# RECORDS OF SEMINAR AND MEETING/DISCUSSION

# The Project for the Study on Improvement of the Bridges through Disaster Mitigating Measures for Large Scale Earthquakes in the Republic of the Philippines 1st Seminar

Date and Time: 6 August 2012, 9AM

Figure 2 DPWH current design practice need for seismic design

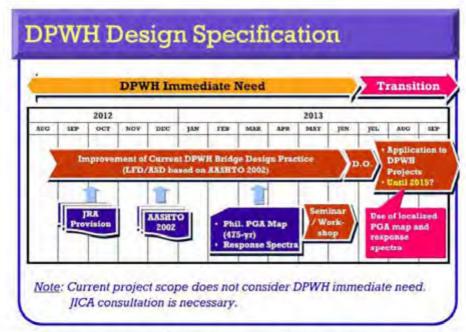
. JICA Study Team (hearafter called as Study Team) suggested the development of contour maps of PGA (475-yr return period) in this project since DPWH will continue to use the current design practice based on "AASHTO LFD, 2002" during the transition period. The suggested plan for the immediate needs is shown in Figure-2.

DPWH's immediate need will be a contour map of PGA (475-yr return period), localized response spectra based on local soil conditions and JRA provisions (including liquefaction evaluation) applicable to the current design practice

Study Team will provide "the 475-yr return PGA contour maps" and "the localized response spectra" by June 2013 (the end of the project).

. In this regard, Study Team informed that the work scope for Study Team will consul with DPWH's immediate need isn't considered in the current project JICA about the plan. scope.
